Re: Williamson County Emergency Services Operations Center CM
Job No: 172201

Subj: Change Proposal No. 172201-0028

We respectfully submit our proposal for an increase to our contract in the amount of \$0 (zero) dollars to provide Added telecom per the Counties request. (Ladder Rack in RM 77, RFI 122, & Cabling for Make Busy Switches) for the above referenced project.

TECHNOLOGY TELECOM
PLAN - AREA A

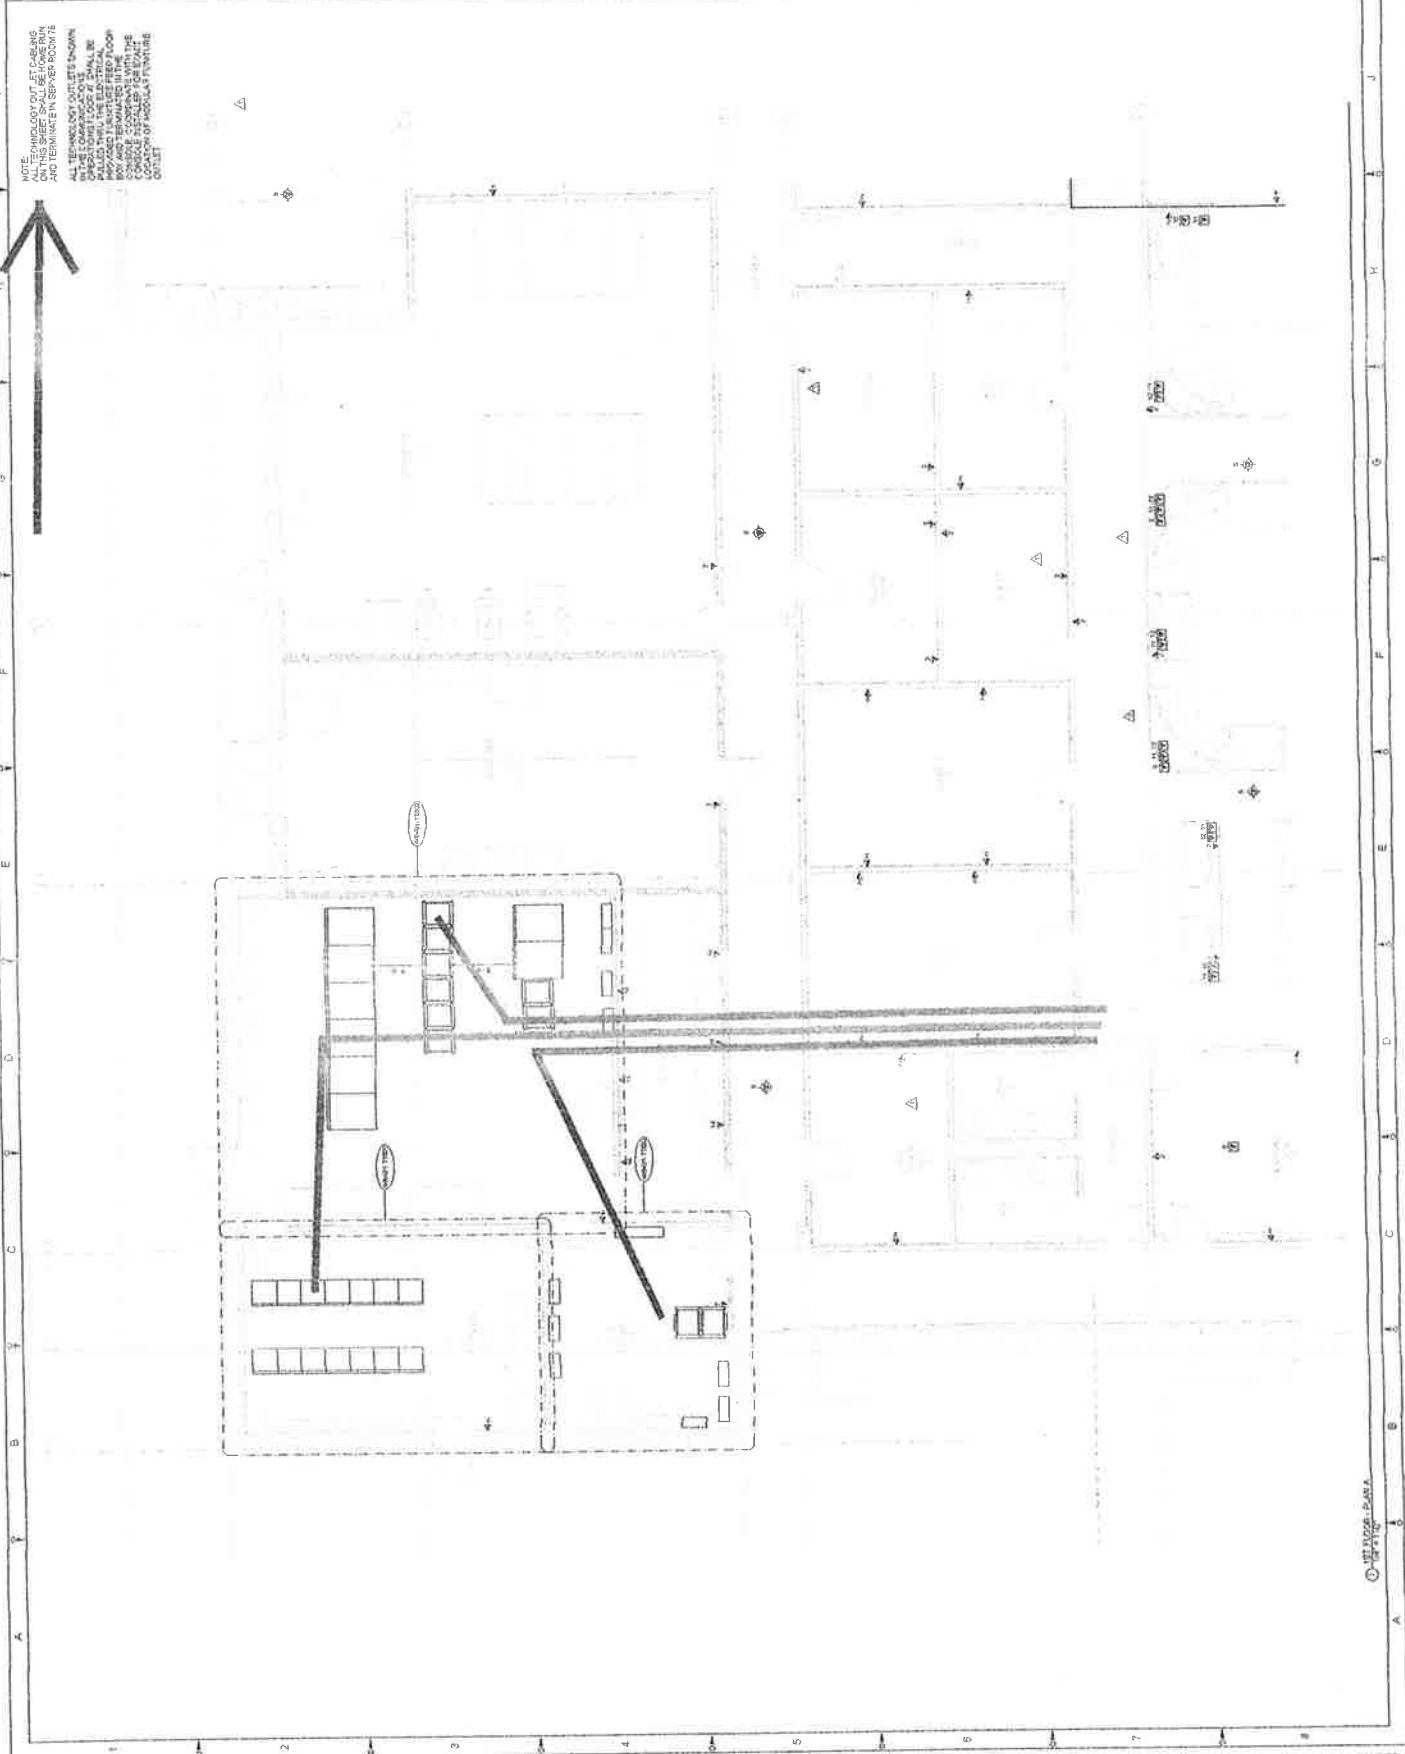
In reference to the TT-200 series of the Construction Documents, all telecom outlet cabling shall be home run and terminated in either Server Room 76 or Telecom Room 32. Per the attached email correspondence and diagram provided by R. Semple, Williamson County has requested that all Motorola outlet cabling be routed directly to and terminated in Motorola Room 77, and all CAPCOG/AT&T outlet cabling be terminated in Pots Demark Room 78, in lieu of this cabling being home run and terminated in Server Room 76. Please reference the following items and provide additional clarification regarding this request.

1. Motorola Cabling: In reference to Sheet TT-000, please advise which telecom symbols and associated outlet cabling shall be routed directly to and terminated in Motorola Room 77.
2. CAPCOG/AT&T Cabling: In reference to Sheet TT-000, please advise which telecom symbols and associated outlet cabling shall be routed directly to and terminated in Pots Demark Room 78.
3. Please advise if additional cable tray will be needed, or if any cable tray routing revisions will be required to accommodate this request.
4. Please advise if these new requirements will affect outlet cabling outside of Comm. Ops. Room 40 (i.e. symbol's 16 & 17 in Room 26 and symbol 17 in EOC Room 39).

I spoke with Randy Rogers this morning and he mentioned that ATT/Capcog does not want their cabling to be terminated in the Server Room 76 as noted on the plans (see the attached). They would like their cabling to be routed directly to the Pots Demark Room 78 and terminated. If this is what Wilco would like to do please send a PR showing the changed routing.

1. Outlet  and  shall be routed directly to and terminated in Motorola Room 77.
2. Outlet  and  shall be routed directly to and terminated in Pots Demark Room 78.
3. Additional cable tray should not be needed for the reroute of the specified cable.

4. Refer to Answer 1 and 2.

Motorola cabling: Room 77

CAPCOG/AT&T: Room 78

All other technology cabling: Room 76
